Nine Mile Point Nuclear Station

License Renewal Application – Responses to NRC Requests for Additional Information Regarding Sections 2.2, 2.3.3, and 2.3.4 (TAC Nos. MC3272 and MC3273)

ATTACHMENT 1

Responses to NRC Requests for Additional Information (RAI) Regarding

FIGURE XI-4
UFSAR Rev. 14 (June 1996)

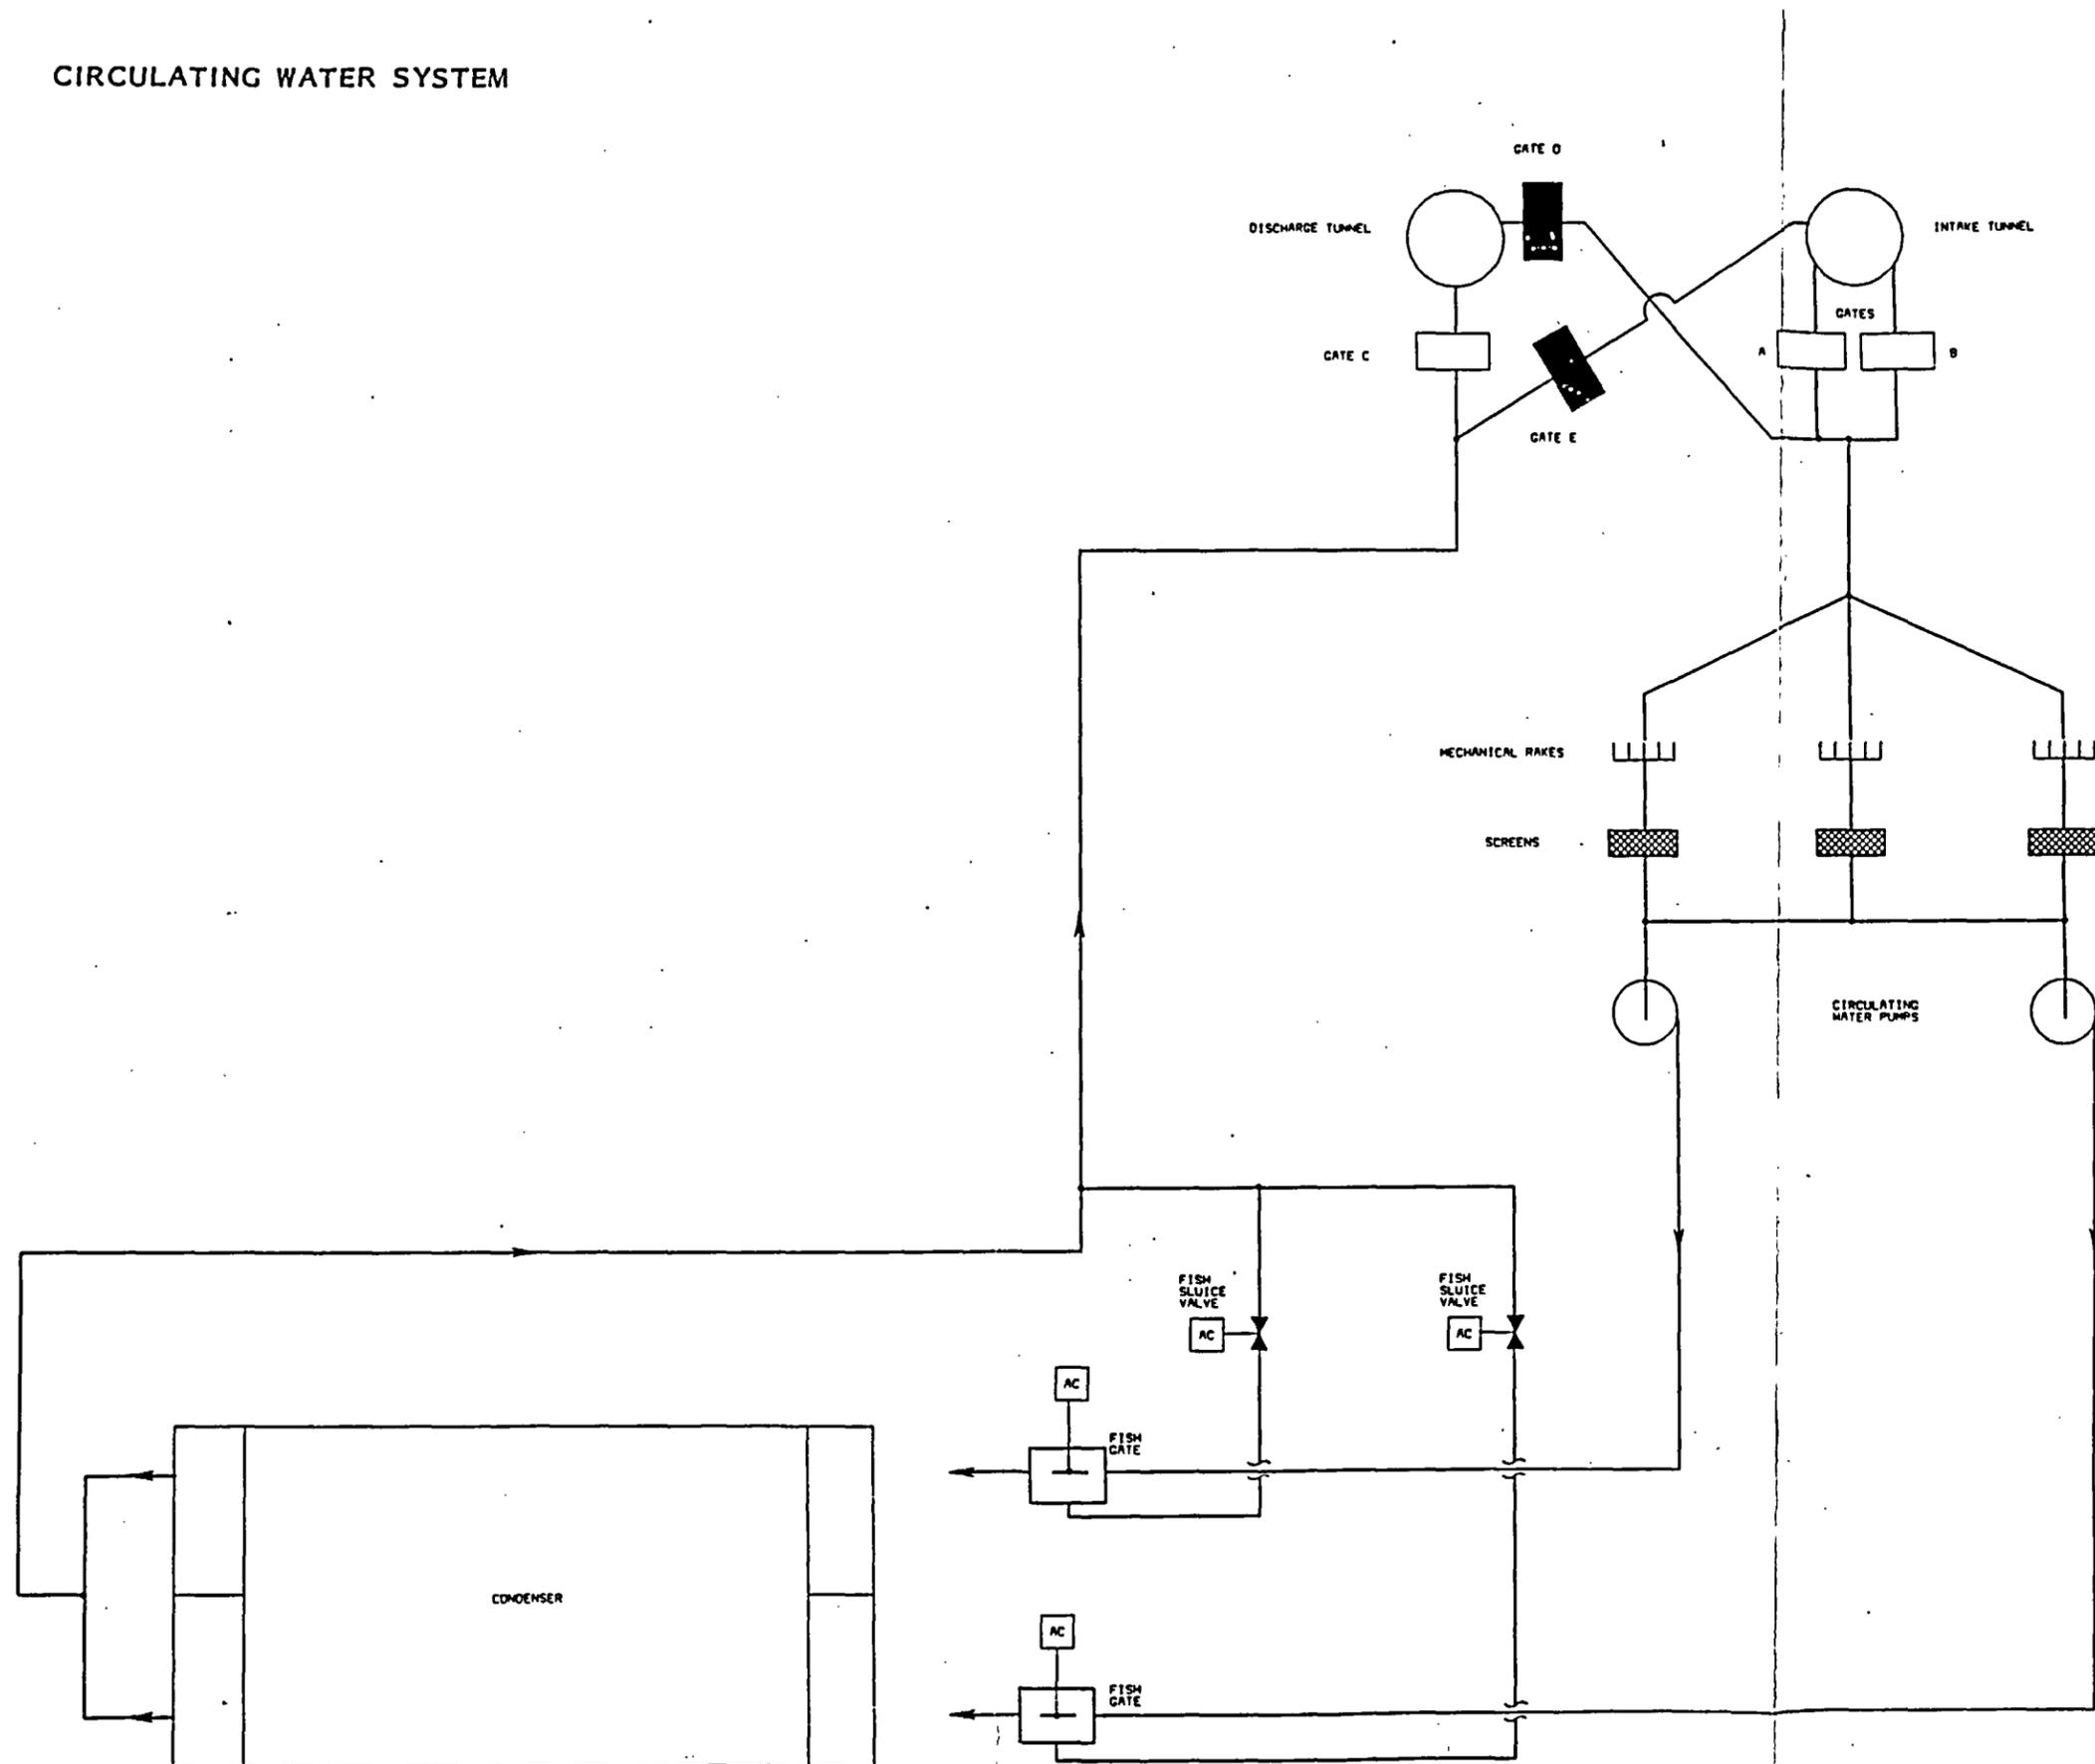
The circulating water system is shown on drawings LR-18022-C, sheet 1 and LR-26941-C. Because of the unique interface between the circulating water system, the emergency service water pumps, and the intake structure, the staff needs more information to complete its review to understand the configuration of the components requiring AMR. This information is not clearly depicted in the LR drawings. Supply the following figures from the NMP1 FSAR: XI-4, Circulating Water System; III-19, Circulating Water Channels under the Screen and Pump House - Normal Operation; III-20, Circulating Water Channels under the Screen and Pump House - Special Operations; and III-21, Intake and Discharge Tunnels Plan and Profile.
